SECTION 4.0 REVISIONS TO THE TEXT OF THE DRAFT PEIR

4.1 CHANGES TO THE PROJECT DESCRIPTION SINCE CIRCULATION OF THE DRAFT PEIR

Revisions to the Proposed DSAP/General Plan Land Use Designations

Below are revisions to the text of the Draft PEIR based on the changes to the Project Description for the Diridon Station Area Plan, dated December 2013. Revised or new language is underlined. All deletions are shown ~~with a line through the text~~.

Fig. 3 – Possible Day-Lighted Creek Channel Alignment

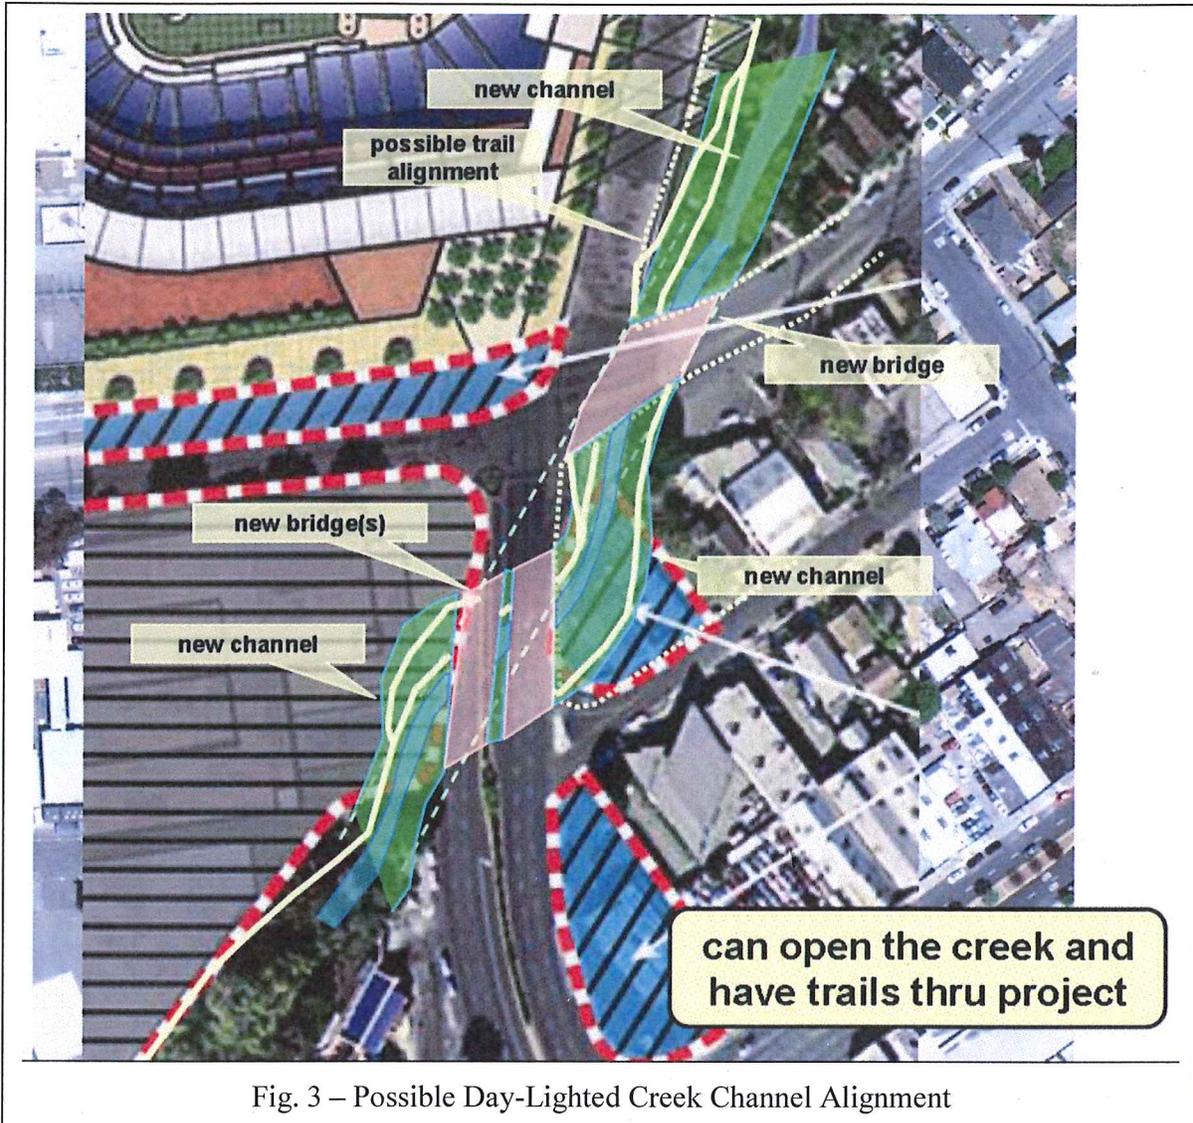
Figure 3 shows a possible alignment of a day-lighted Los Gatos Creek: the green represents the restored creek channel, the blue the stream itself, and the yellow lines show possible trail alignments. The channel utilizes land that is to be acquired for the planned street realignment (the blue areas surrounded by red/white dashed lines), and it presumes that this intersection will be reconfigured according to the new City policy to remove the non-stop right-turn ramps.

Fig. 3 – Possible Day-Lighted Creek Channel Alignment

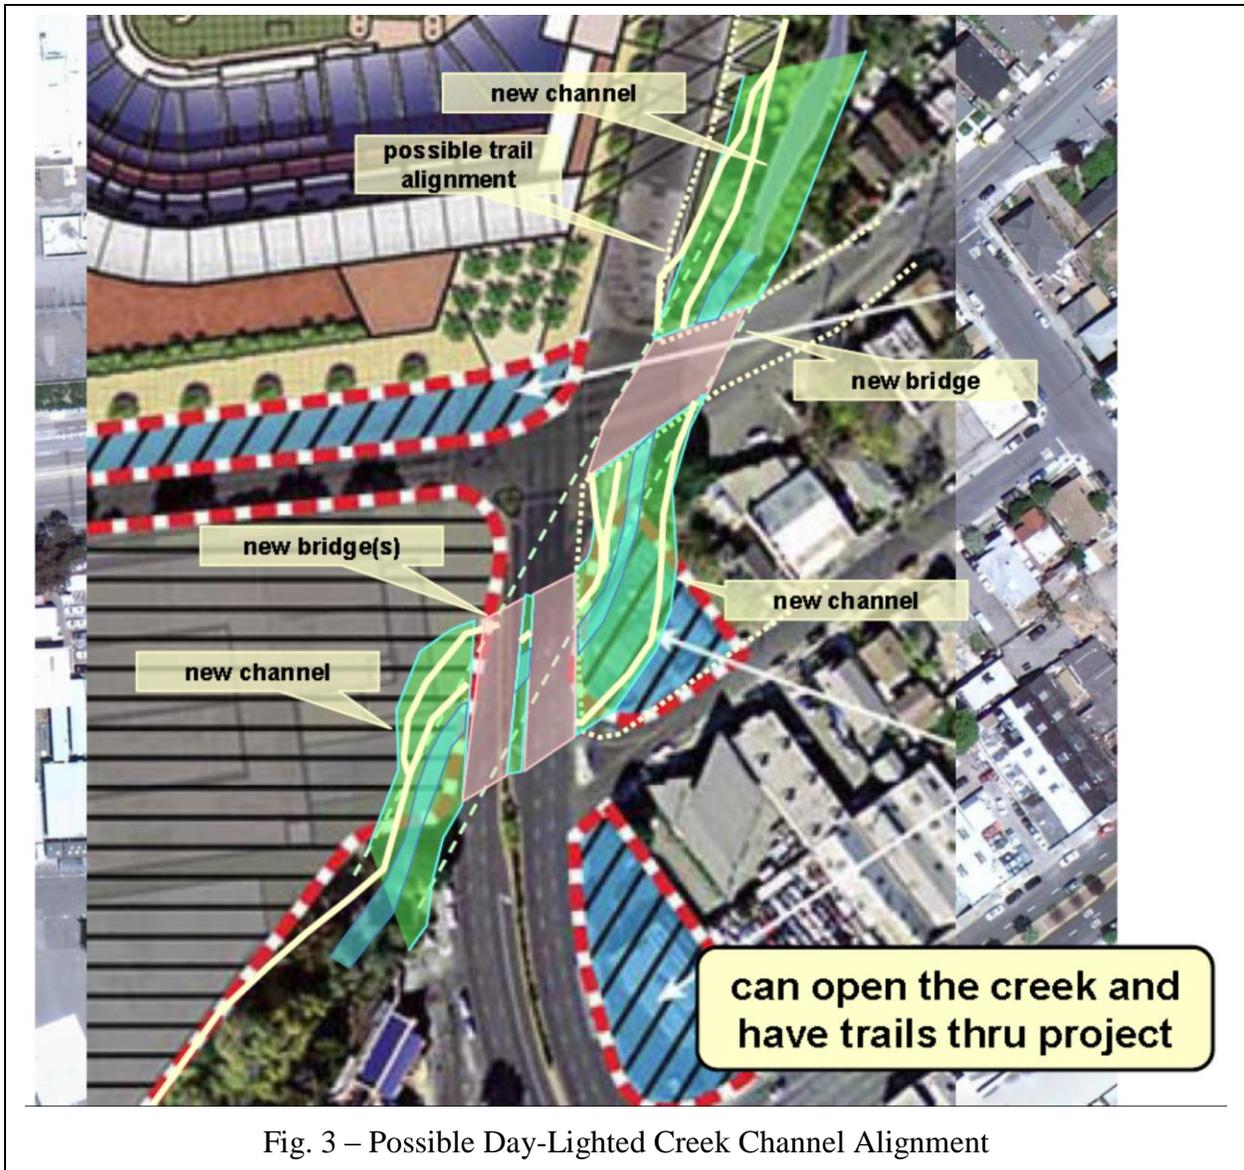
Figure 3 shows a possible alignment of a day-lighted Los Gatos Creek: the green represents the restored creek channel, the blue the stream itself, and the yellow lines show possible trail alignments. The channel utilizes land that is to be acquired for the planned street realignment (the blue areas surrounded by red/white dashed lines), and it presumes that this intersection will be reconfigured according to the new City policy to remove the non-stop right-turn ramps.
